MULTISITE ROOFING 2017
Kelly Middle School
Edgewood Elementary School
C.I.P. No. 420.780.209

ROBERTSON/SHERWOOD/ARCHITECTS pc
132 E. Broadway - Suite 540
Eugene, Oregon
Project No. 1707

This Addendum forms a part of the Contract Documents and modifies the original Bid Documents dated May 8, 2017 as noted below. Acknowledge receipt of this Addendum in the space provided on the Bid Form. Failure to do so may subject Bidder to disqualification.

A
AD1-1

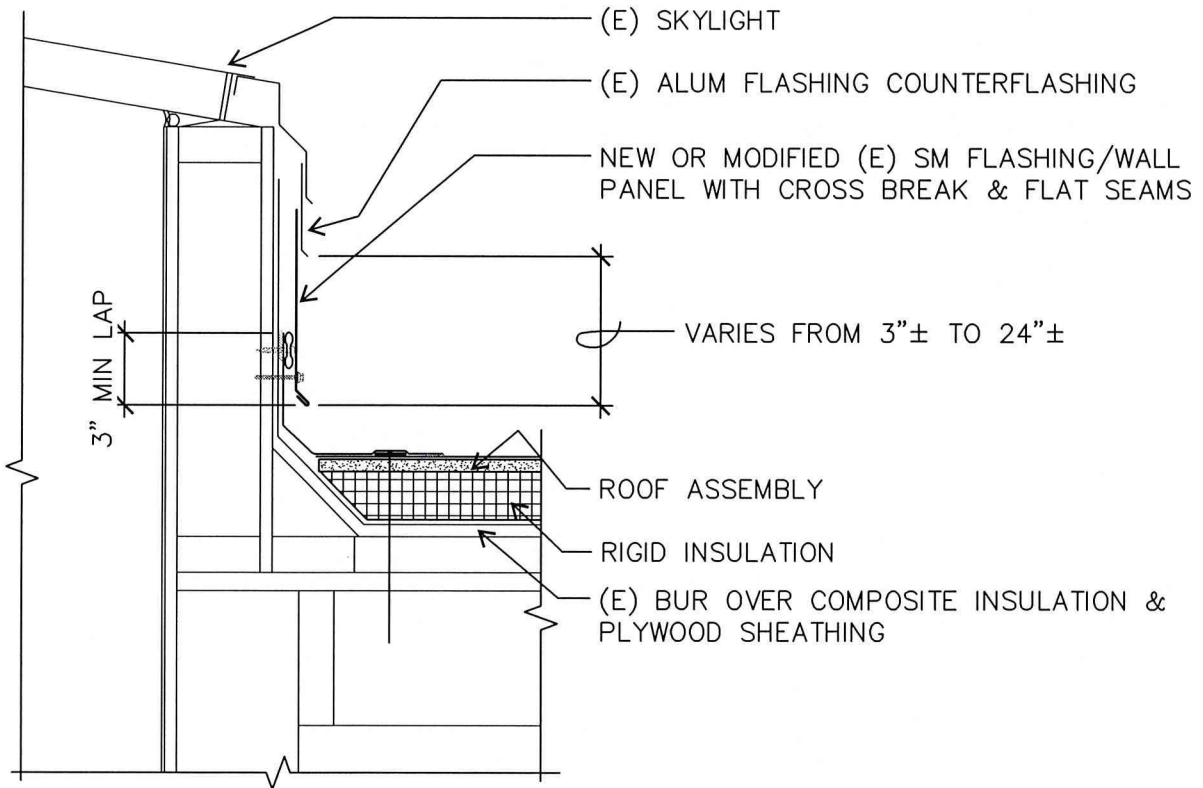
B. Kelly Middle School Roof Plan, B1/A-101: Provide new rigid insulation to lower edge of crickets at walls of Roof 1. Refer to attached Detail AD1-1.

PROVIDE RIGID INSULATION TO THIS POINT, TYPICAL AT CRICKETS AT NORTH, WEST, AND EAST WALLS
